ADDENDUM# 3

**University of Kentucky
2555.0 Delta Gamma House New Construction**

Addendum #03

Written Questions and Answers

YARD INLET (NYLOPLAST DRAIN BASIN WITH ADD-A-BRANCH)
SCALE: NOT TO SCALE

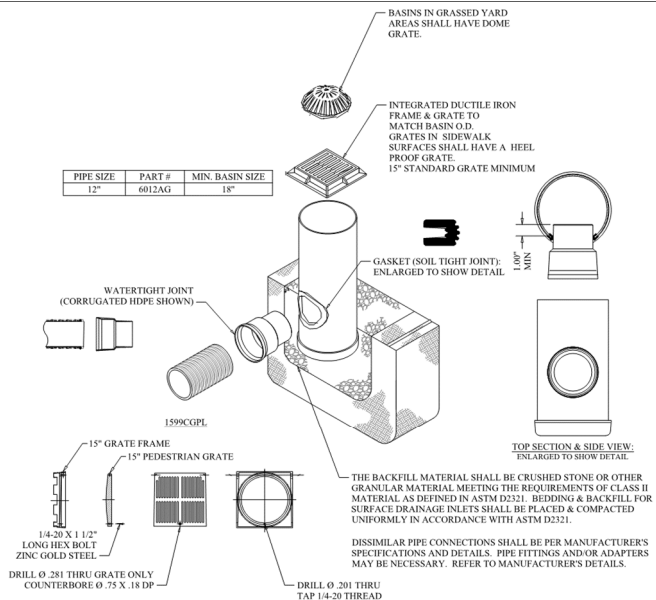
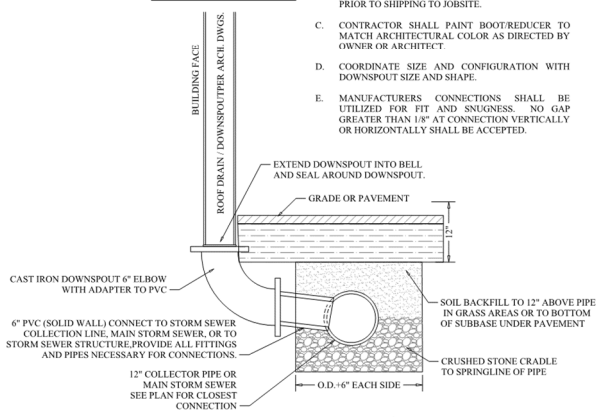
33.	Are we required to carry Builders Risk Insurance, or will the University carry this policy?	UK	Contractors are responsible to carry insurance.
34.	Sheet SD1 reflects a yard inlet detail and downspout collector piping details (see below). Sheet CE3 provides rim elevations for the new structures. Please provide 1) invert elevations for all storm structures and 2) pipe sizes and types for all storm drainage piping. For the downspout collector piping, please reflect the location of this piping on Sheet CE3. Please provide the pipe size and types for the downspout collector piping. Please provide a tie-in location and tie-in invert elevation for the downspout collector piping as well.	Prime AE	Revised Spot elevation sheet attached with inverts, pipe slope, etc shown. Downspout detail shown on SD1. Contractor to coordinate final locations with Architectural plans.

- A. REFER TO ARCHITECTURAL DRAWING AND DETAIL FOR DOWNSPOUT CONNECTION AND ADAPTER.
- B. DOWNSPOUT SHALL BE PAINTED PRIMER (COLOR SELECTED BY OWNER) BY THE MANUFACTURER PRIOR TO SHIPPING TO JOBSITE.
- C. CONTRACTOR SHALL PAINT BOOT/REDUCER TO MATCH ARCHITECTURAL COLOR AS DIRECTED BY OWNER OR ARCHITECT.
- D. COORDINATE SIZE AND CONFIGURATION WITH DOWNSPOUT SIZE AND SHAPE.
- E. MANUFACTURER'S CONNECTIONS SHALL BE UTILIZED FOR FIT AND SMOOTHNESS. NO GAP GREATER THAN 1/8" AT CONNECTION VERTICALLY OR HORIZONTALLY SHALL BE ACCEPTED.

DWG. NO.
A101

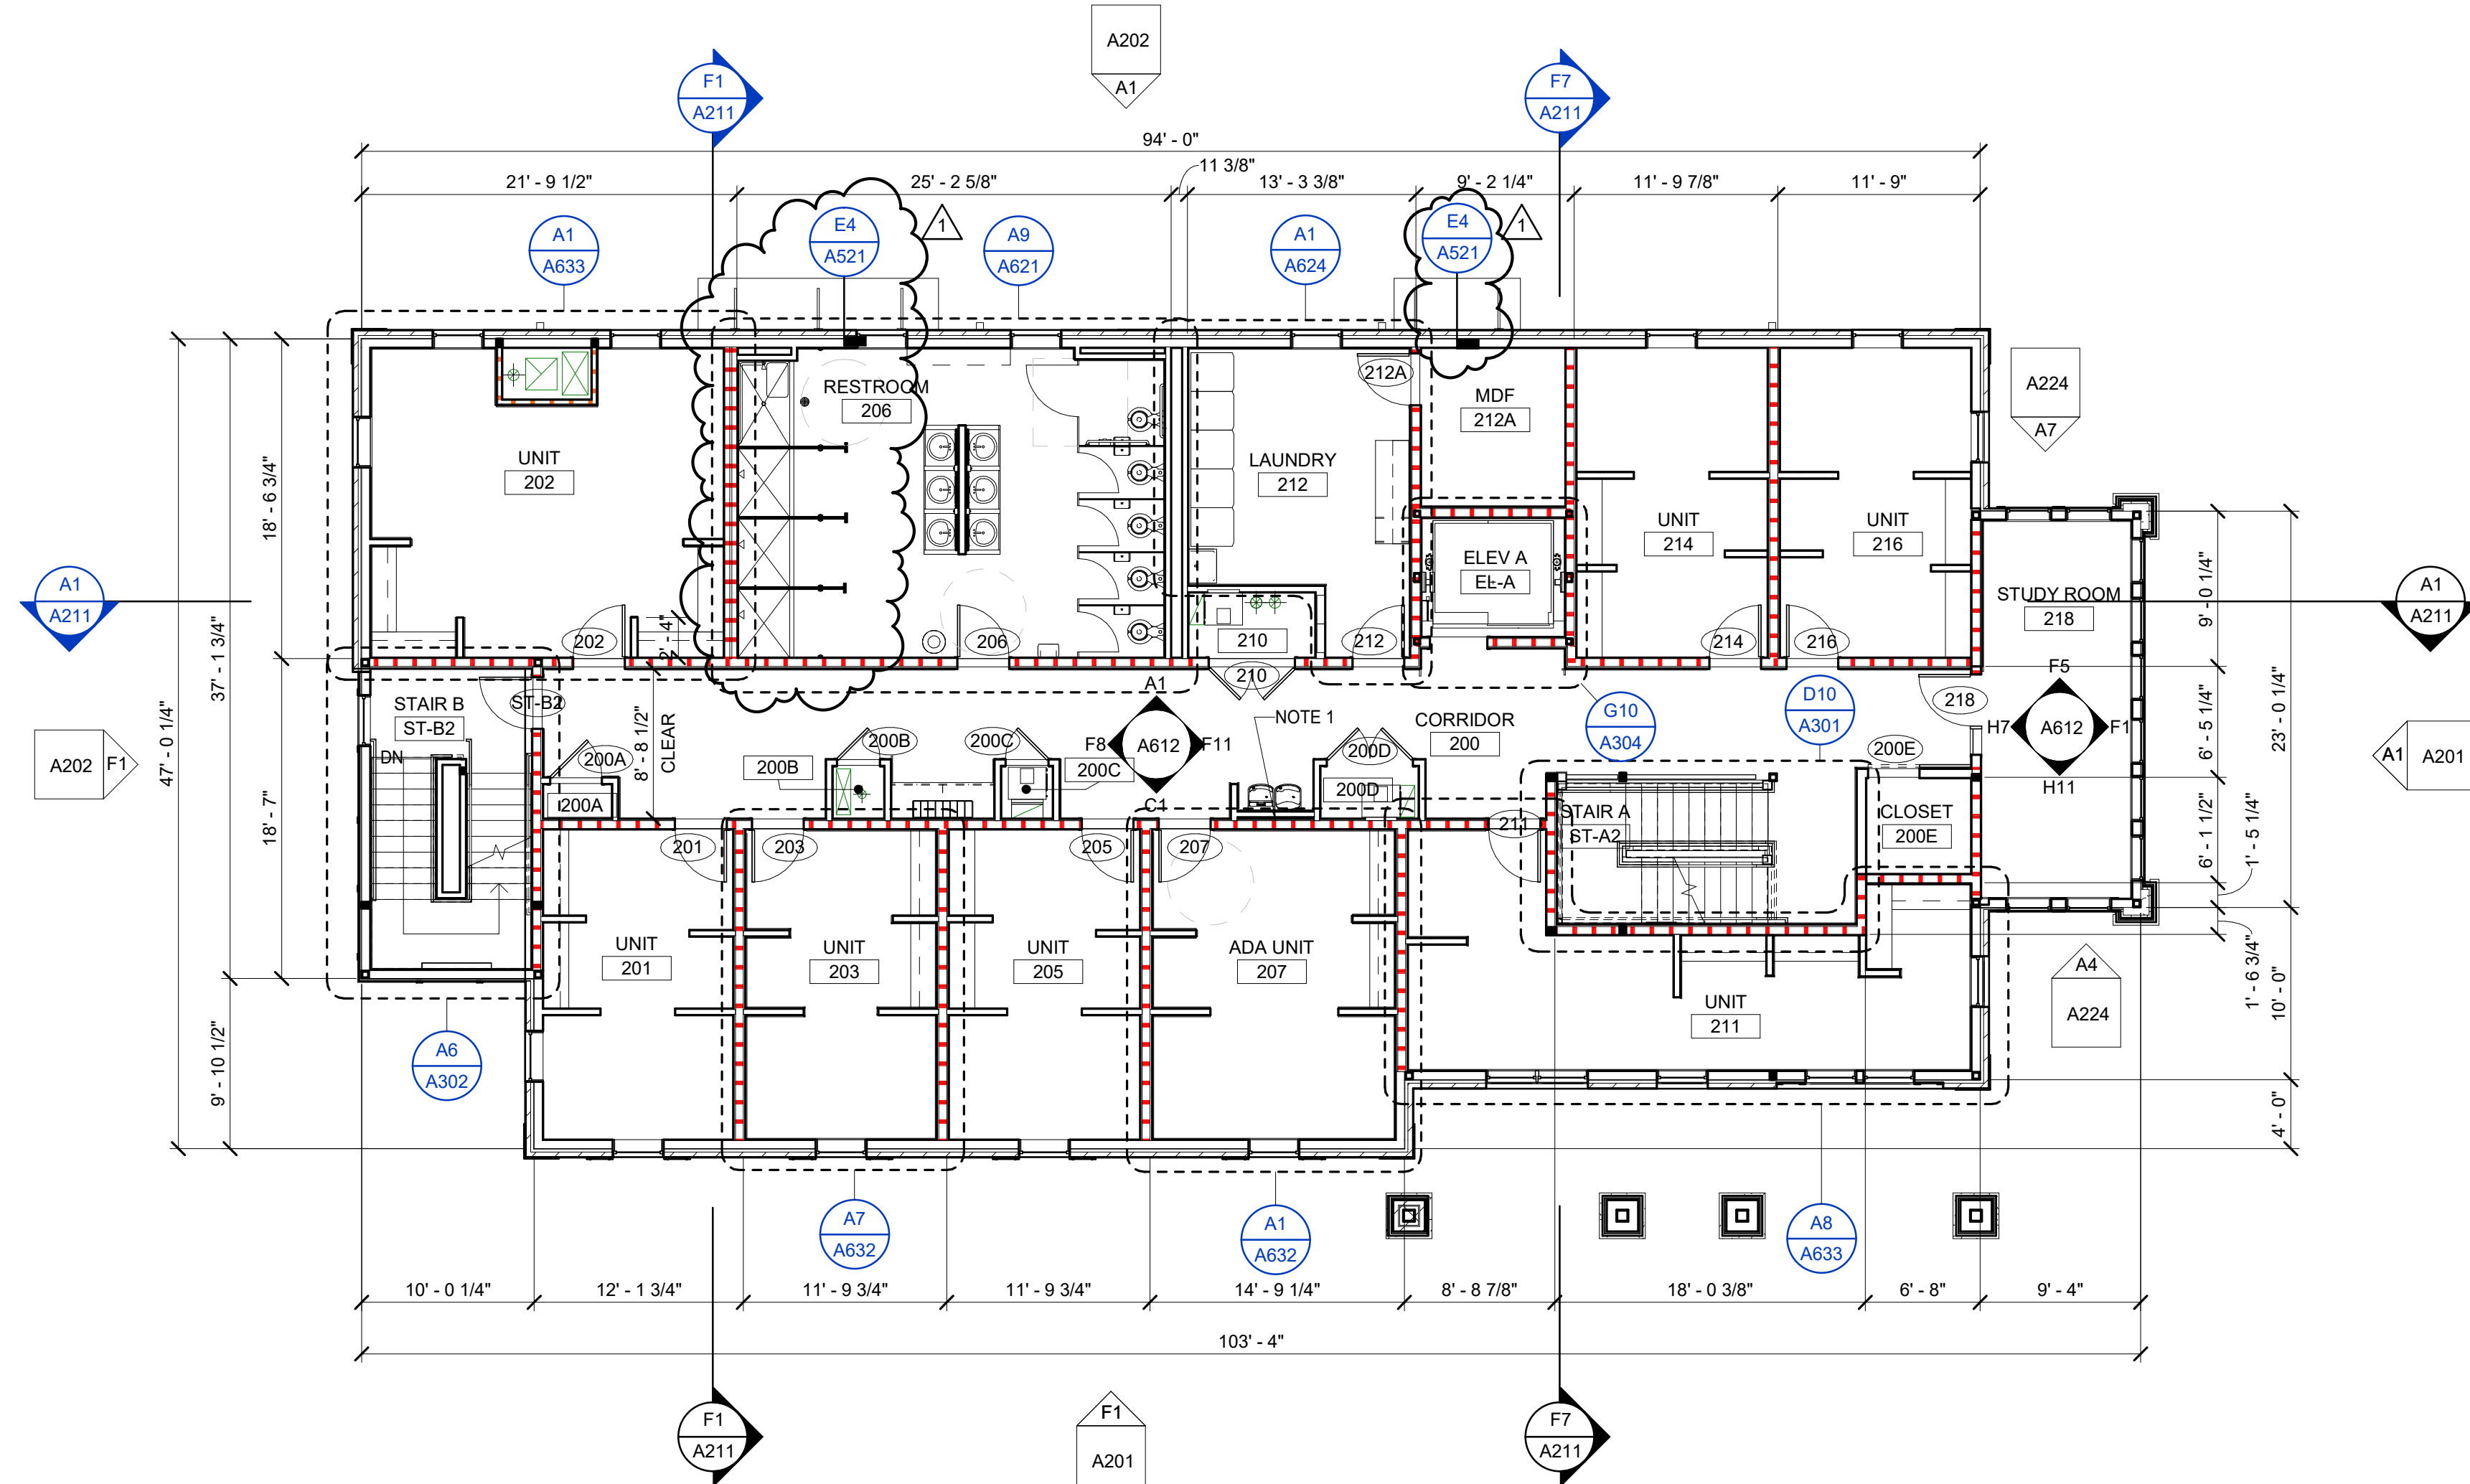
Sheet#:	Title	Date
A101	FLOOR PLAN – LEVEL 01 <ul style="list-style-type: none"> Added mop sink per jurisdiction review. 	10/26/22
A102	FLOOR PLAN – LEVEL 02 <ul style="list-style-type: none"> Restroom modifications in response to Contractor questions. Detail callout clarification for canopies. 	10/26/22
A103	FLOOR PLAN – LEVEL 03 <ul style="list-style-type: none"> Restroom modifications in response to Contractor questions. Detail callout clarifications. Added a keynote for mop/ broom holder at mop sink 	10/26/22
A525	EXTERIOR DETAILS – FIBERGLASS CORNICE <ul style="list-style-type: none"> Keynote and Sheet note clarifications 	10/26/22
A601	DOOR ELEVATIONS, DETAILS & SCHEDULE <ul style="list-style-type: none"> Added door detail references. Clarified door and frame types per Contractor questions. Note Clarifications on Door Schedule. 	10/26/22
A620	ENLARGED RESTROOM PLAN & ELEVATIONS <ul style="list-style-type: none"> Clarifications in response to Contractor questions. 	10/26/22
